TE Connectivity

Product Change Notification: P-26-030763

2-POS. SEALED 2.8MM USCAR CLEAN BODY FOR

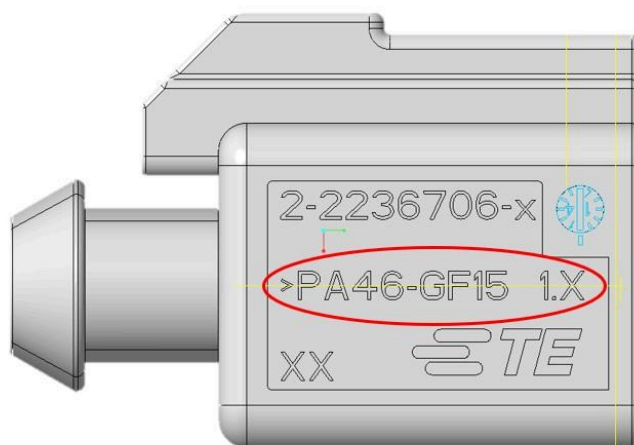
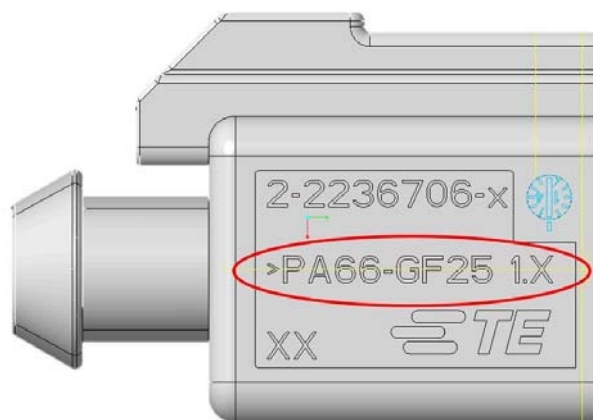
This product change notification (PCN) is to inform you about a material change from PA46-GF15 to PA66-GF25 impacting the PNs listed below in this PCN.

Product improvement.Change the material for the housing 2236697-1 from PA46-GF15 to PA66-GF25. Affected TCPNs:2-2236706-1 / 2-2236706-2 / 2-2236706-3 / 2-2236706-4 / 2236697-1 Affected Drawings: 2236697 / 2236706
